Access Compliance Report Public Rights-of-Way (Curb Ramps)

Main Street: DANBURY Cross Street: MAYBECK_LN Location: SE

ADA ID: RPRK211025112942 Ramp Type: Type 4 - Parallel Initial Pass/Fail: Fail Overall Compliance: No Severity Score: 2

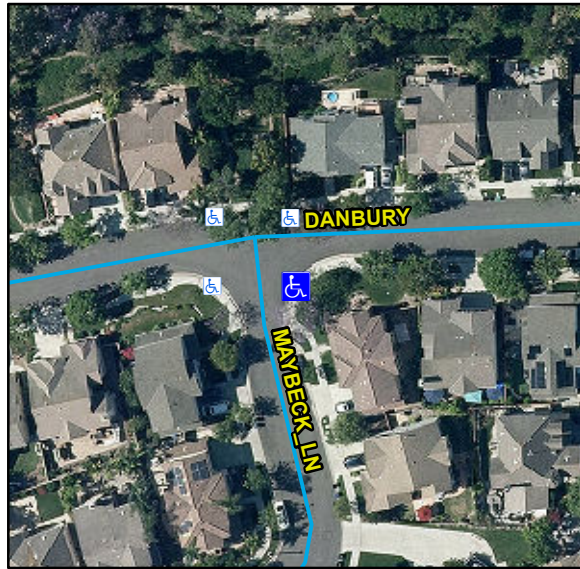
R204.3, R304.5.3, STD 1115

Remove & Replace Curb Ramp With Two New Directional Ramps or Equivalent.
